Item 7:

DC/22/3493/FUL

Proposed two storey part side/part rear extension, single storey rear extension and alterations

54 Looe Road, Felixstowe,
Suffolk, IP11 9QB

PROPOSED GROUND FLOOR PLAN 1:50

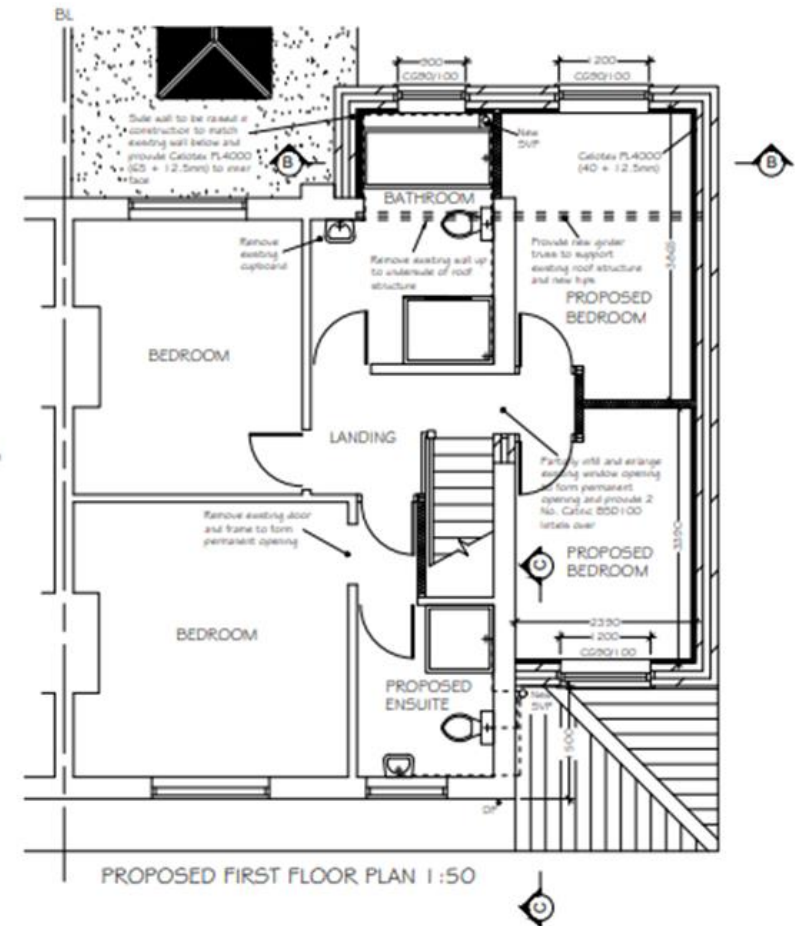
Committee recommended REFUSAL. Whilst we are content with all other aspects of the proposals, we feel that, because of the intense demand of on street parking in Looe Road, with both an increase in the number of bedrooms to this property and loss of the garage - resulting in the property only having one off-street parking space - is unacceptable, in accordance with County Council parking guidance which would require three spaces.
